Proposed Plan of Subdivision
Part Lot 13 and Part of Part 1
Reference Plan 28R-12528
(WILDWOOD CRESCENT – PHASE II)

Owner: Spring Valley Homes Ltd. (Michael Veenstra) Agent: Collett Surveying Ltd. File: 08T-955001(D) 30 August 2011
REPORT TO ECONOMIC DEVELOPMENT PLANNING COMMITTEE - PUBLIC MEETING - 06 SEPTEMBER 2011

2011-086-09
PROPOSED PLAN OF SUBDIVISION
PART LOT 13 AND PART OF PART 1
REFERENCE PLAN 28R-12528
CITY OF BROCKVILLE
(WILDWOOD CRESCENT – PHASE II)
OWNER: SPRING VALLEY HOMES LTD.

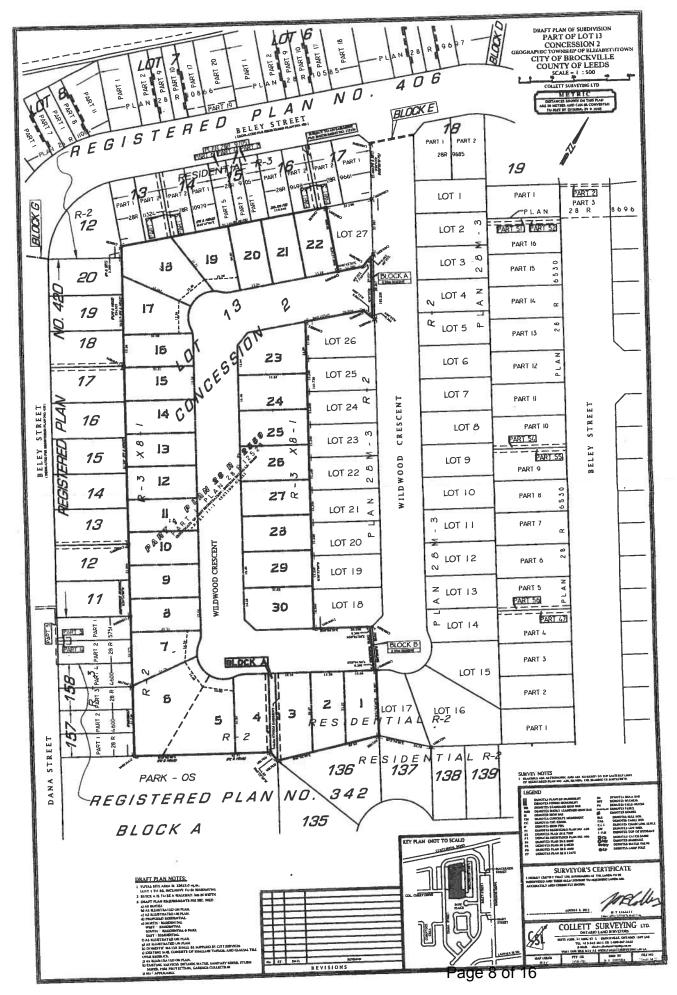
In addition to being part of a storm easement, as noted on the plan, Block 'A' must also allow for a walkway to connect Wildwood Crescent to the Dana Street park. The walkway is to be constructed at the developers expense."

"After reviewing the plans for the above-noted project, please be advised that further information is required to provide comments (location of existing and proposed hydrants)."

The plan does not include a storm easement that was shown on the last drawing the CRCA was circulated (2005). The storm easement was located between Lots 43 and 44 on the 2005 plan or Lots 6 and 7 on the new plan.

Have revised Lot Grading and Drainage Plan/Servicing Plan and Profile Drawings been submitted with the new application? If not will the City of Brockville be requiring these due to the revision?
